Administrative Committee of the European Agreement
Concerning the International Carriage of Dangerous
Goods by Inland Waterways (ADN)

Draft amendments to the Regulations annexed to ADN

At its sixteenth session (Geneva, 29 January 2016), the ADN Administrative Committee requested the secretariat to prepare a consolidated list of all the amendments it had adopted for entry into force on 1 January 2017 so that they could be made the subject of an official proposal in accordance with the procedure set out in article 20 of ADN. The notification would have to be issued no later than 1 July 2016, with a reference to 1 January 2017 as the scheduled date of entry into force (see ECE/ADN/35, paragraph 15).

Figure 5.2.1.9.2

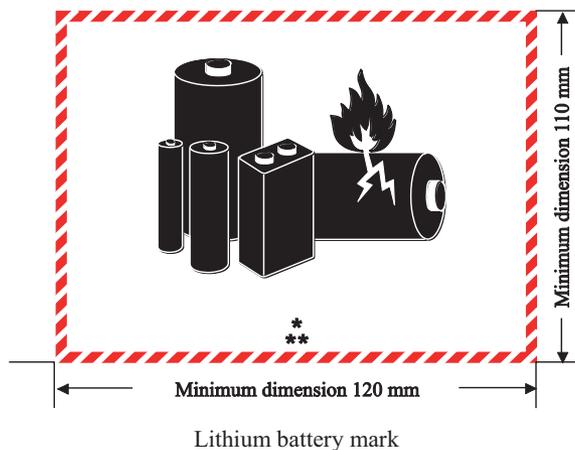
5.2.1 Add a new 5.2.1.9 to read as follows:

5.2.1.9.1 Packages containing lithium cells or batteries prepared in accordance with special provision 188 shall be marked as shown in Figure 5.2.1.9.2.

5.2.1.9.2 The mark shall indicate the UN number preceded by the letters “UN”, i.e. ‘UN 3090’ for lithium metal cells or batteries or ‘UN 3480’ for lithium ion cells or batteries. Where the lithium cells or batteries are contained in, or packed with, equipment, the UN number preceded by the letters “UN”, i.e. ‘UN 3091’ or ‘UN 3481’ as appropriate shall be indicated. Where a package contains lithium cells or batteries assigned to different UN numbers, all applicable UN numbers shall be indicated on one or more marks.

Examples of stowage and segregation of containers

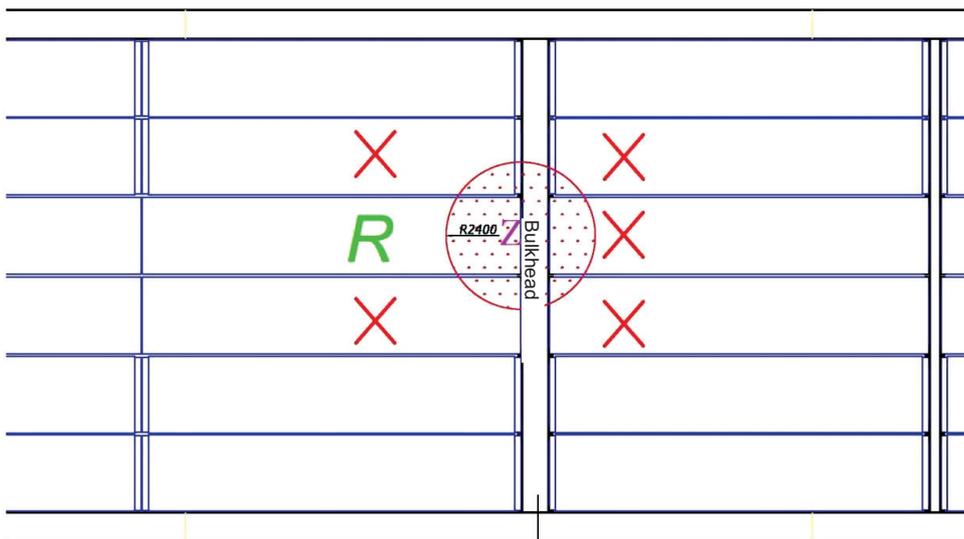
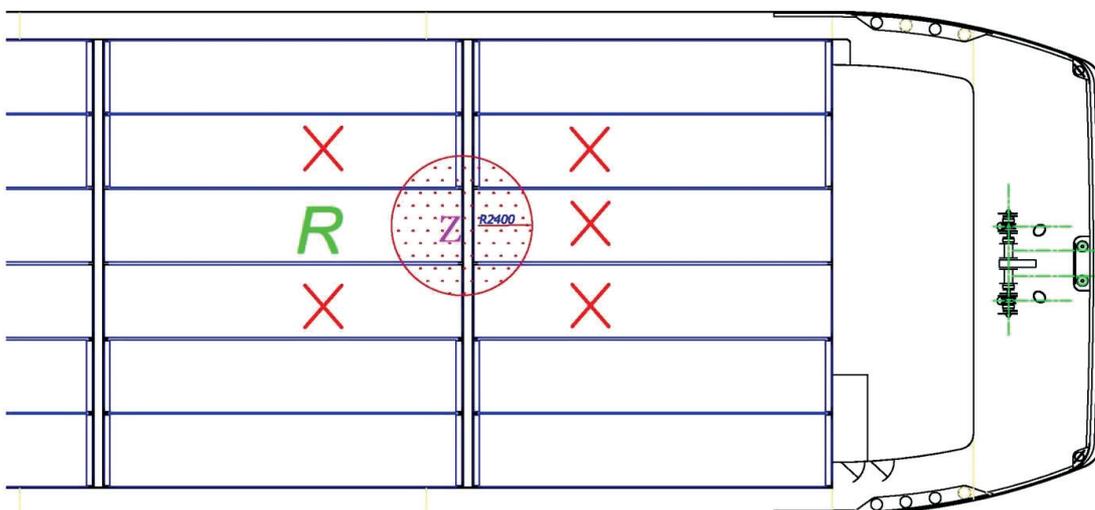
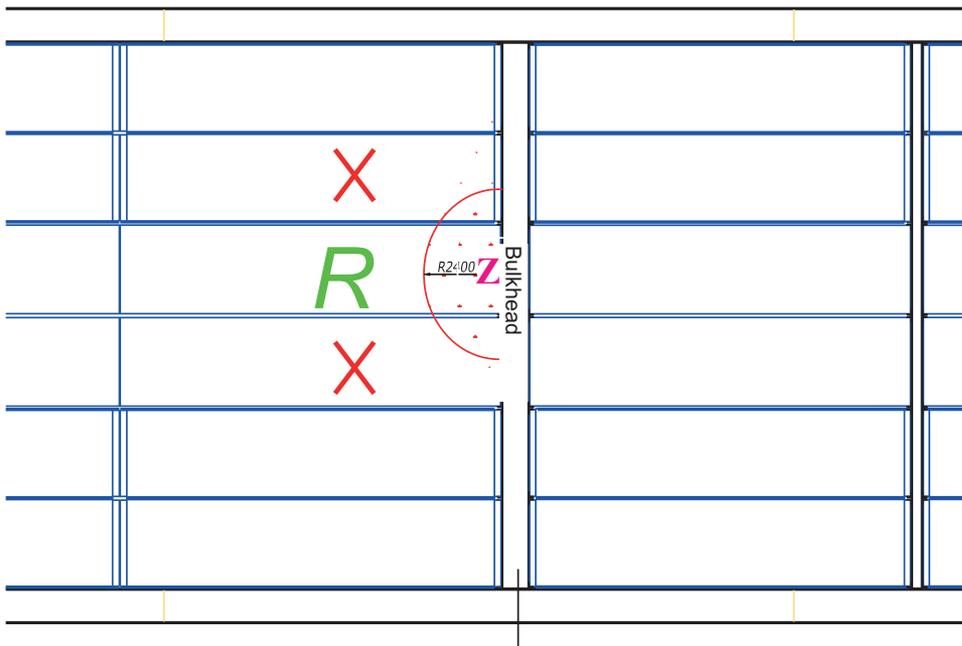
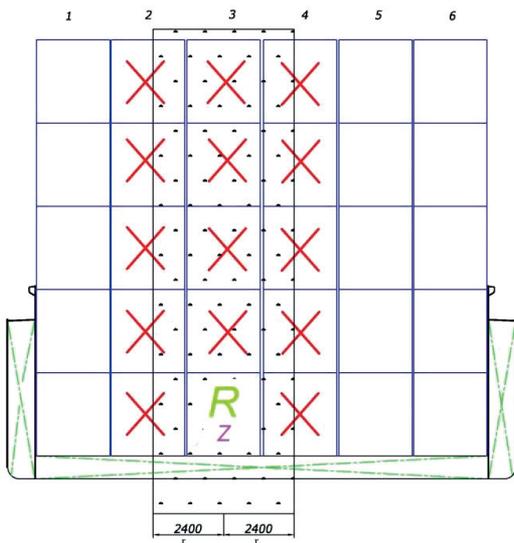
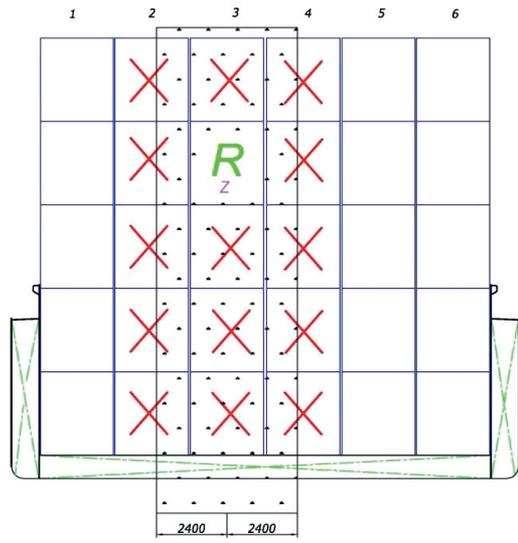
7.1.4 Insert a new 7.1.4.4.5 to read as follows:

“7.1.4.4.5 The electrical equipment fitted to an open container may not be connected with removable electrical cables in accordance with the provisions of 9.1.0.56 nor be put into operation unless it is of a certified safe type or the container is placed in a hold which does not contain containers with substances referred to in 7.1.4.4.4 (b).”
